In Reply Refer To: HSSD/B-164

Thank you for your August 14, 2007, letter requesting the Federal Highway Administration's (FHWA) acceptance of an F-shape portable concrete barrier wall as a test level 3 (TL-3) device for use on the National Highway System (NHS). Accompanying your letter were drawings of the details of the barrier, connections, and reinforcement and a comparison of this design with previously crash tested barriers. You requested that we find this device acceptable for use on the NHS under the provisions of National Cooperative Highway Research Program (NCHRP) Report 350 "Recommended Procedures for the Safety Performance Evaluation of Highway Features."

501.45 UNLESS OTHERWISE NOTED, ALL DIMENSIONS ON THIS SHEET ARE IN MILLIMETERS

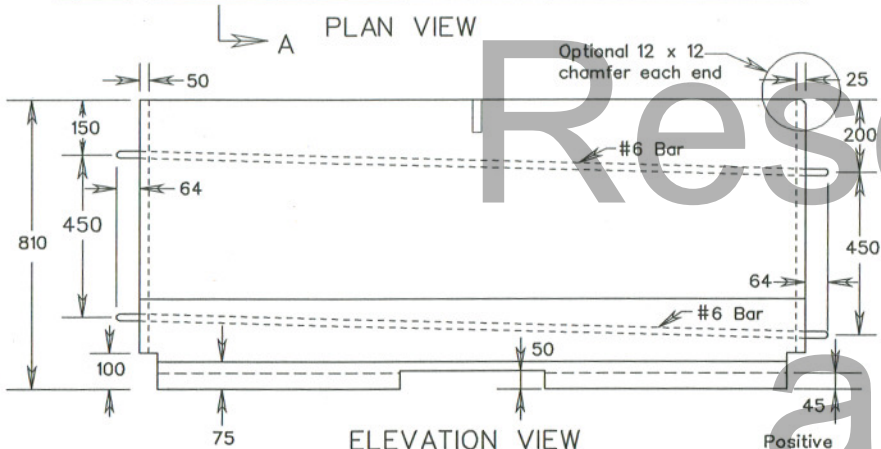
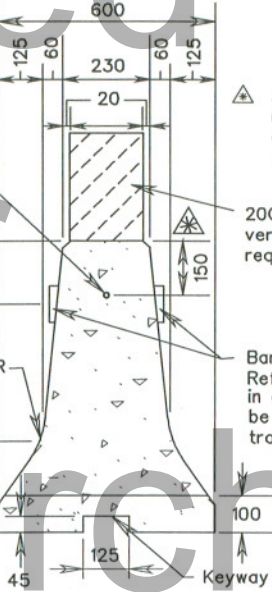
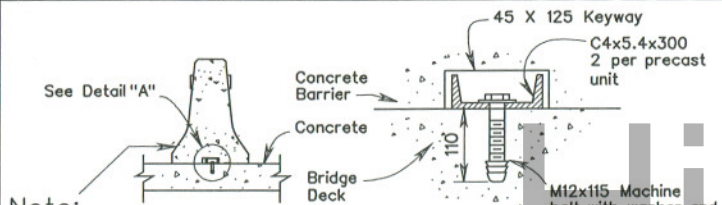
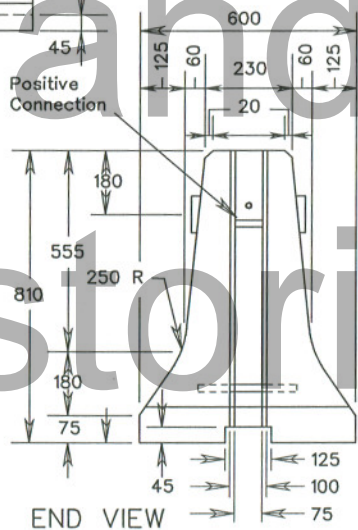
The barrier segments were fabricated in accordance with the Virginia Department of Transportation (VDOT) drawing 501.45 (revised August 1997, copy enclosed for reference). The one difference between the VDOT design and the barrier design you are requesting is the lack of the #4 reinforcing bar at the top of the wall. The FHWA acceptance letter B-54 dated May 18, 1999, describes the VDOT barrier:

The VDOT barrier was found acceptable in both 10-foot and 20-foot long sections. An analysis of the reinforcing steel shows that, even minus the #4 bar noted above, the longitudinal steel in the barrier you requested is comparable to that found in other crash tested barrier segments such as the JJ-Hooks Temporary Barrier described in the FHWA acceptance letter B-52 dated March 26, 1999.

The F-shape portable concrete barrier wall described above and detailed in the enclosed drawing is acceptable for use on the NHS as it is deemed an equivalent material meeting NCHRP 350 TL-3, when proposed by a highway agency. The connection pin, nut, and washers should be at least 1 inch in diameter and secured with nuts and washers as were the crash tested VDOT barrier segments. Barrier segment lengths may be 10 feet or 20 feet.
